ERRATA SHEET

TENNESSEE VALLEY AUTHORITY

WATTS BAR RESERVOIR LAND MANAGEMENT PLAN (WBRLMP) LOUDON, MEIGS, RHEA, AND ROANE COUNTIES, TENNESSEE

ENVIRONMENTAL IMPACT STATEMENT

Figure 1. Excluded Parcels Near Kingston Fossil Plant

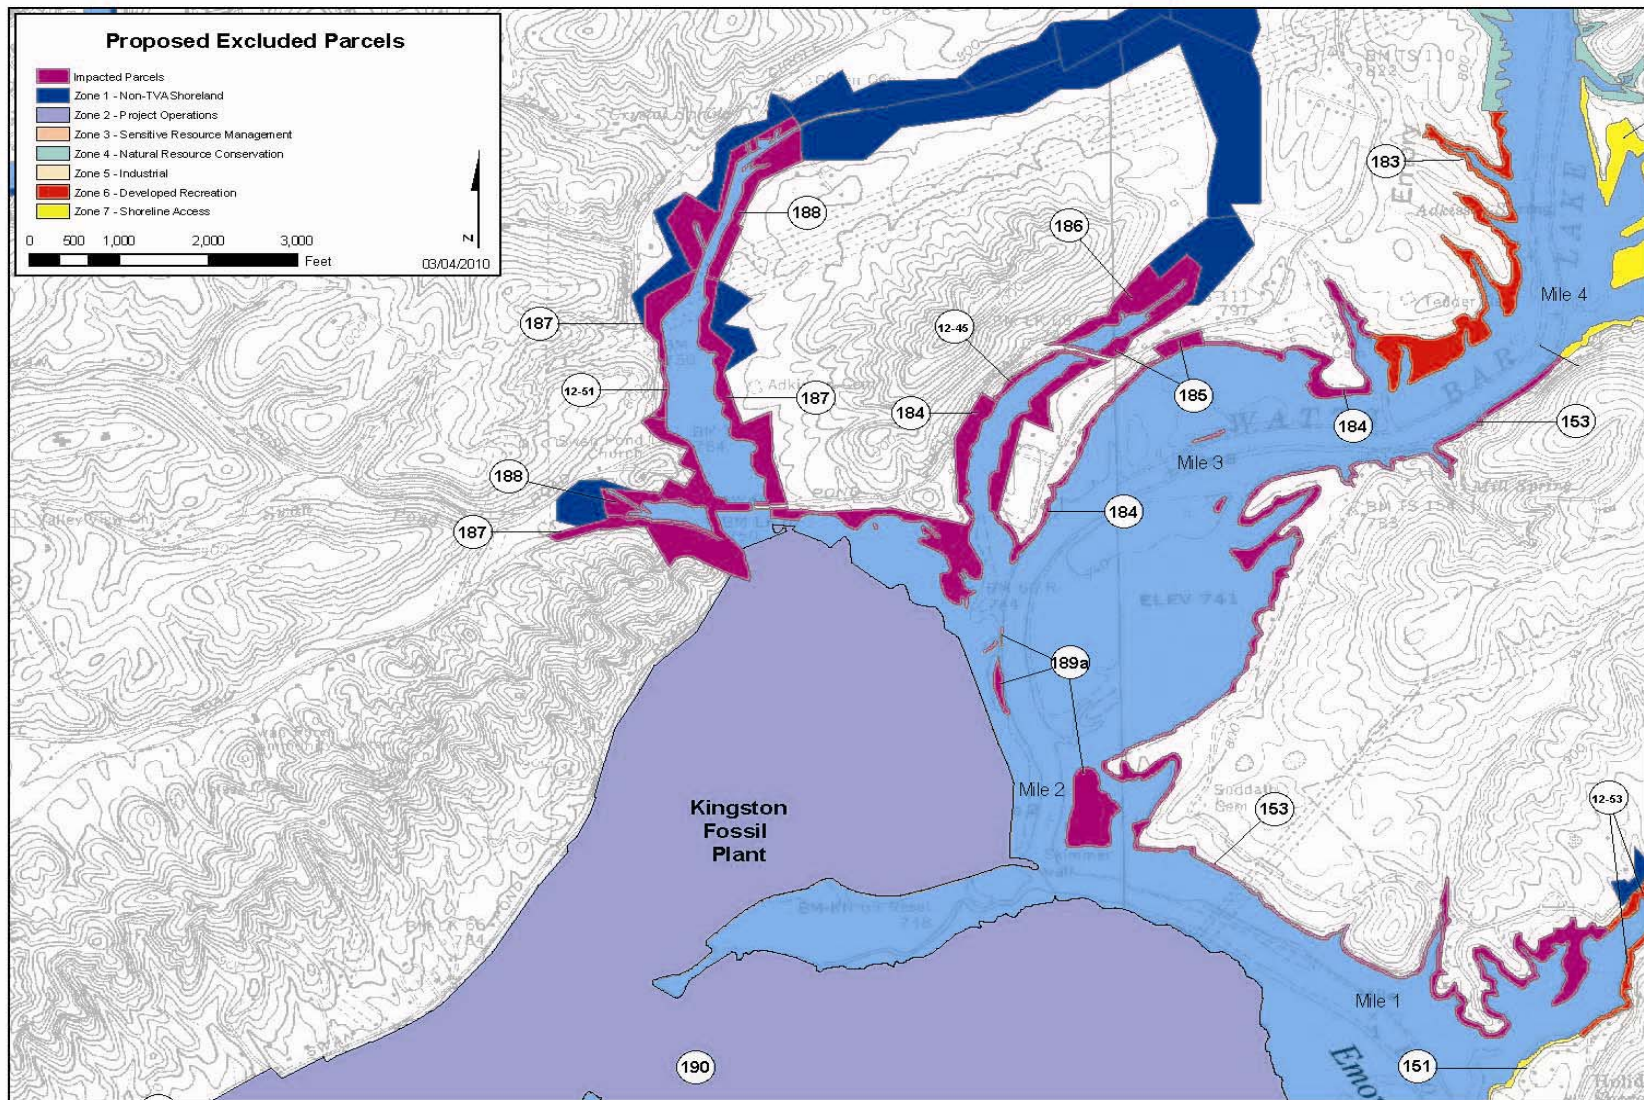
Since the release of the final EIS, Parcel 189a was determined to include several islands (totaling 8 acres) located upstream of the spill site on the Emory River. This location was not impacted by the spill; therefore, these islands should not have been part of the affected area. Furthermore, there are three additional parcels (Parcels 185, 186, and 153) totaling 58.4 acres that were affected by the Kingston ash spill. The total revised area of the parcels impacted by the spill is 184 acres (see Table 1 below). The locations of these parcels are shown in Figure 1 below.

Most of the changes necessary to accommodate the 184-acre reduction occur in various tables throughout the document; however, some changes in the document text are necessary. An updated map of the Kingston Fossil Plant area (i.e., Figure 1 in this document) is provided. Table 2 lists the locations in the document where updates are necessary.
